**Historic Architectural Review Commission
Staff Report for Item 4**

Application Number: 18-2459

Address: #1 Whitehead Street

Installation of aluminum impact doors at front entry of the Key West Aquarium.

FRONT ENTRY DOOR TO AQUARIUM

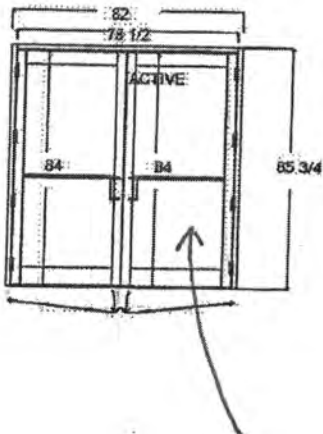
This proposal is a little unusual in that the replacement is for a door that is not the original fenestration for that part of the building, nor is it compatible with the character of the contributing building. The Secretary of the Interior’s Guidelines for Rehabilitation for Entrances and Porches and Storefronts contain very similar recommendations for “Designing the Replacement for Missing Historic Features.” The Entrances and Porches section recommends, “Designing and installing a new entrance or porch when the historic feature is completely missing or has been previously replaced by one that is incompatible. It may be an accurate restoration based on documentary and physical evidence...or it may be a new design that is compatible with the size, scale, *material*, and color of the historic building” (Emphasis added) (Page 112). That section is clear in that the replacement feature should match the style and material of the historic feature. While it would be difficult for the applicants to convert the door back to a window due to current use, it is recommended that they install doors (such as a wood, half glazed French door) that more accurately reflects the character of the original windows.

Therefore, staff finds the proposal inconsistent with the guidelines, the Secretary of the Interior's Standards, and the Secretary of the Interior's Guidelines for Windows, Entrances and Doors, and Storefronts.
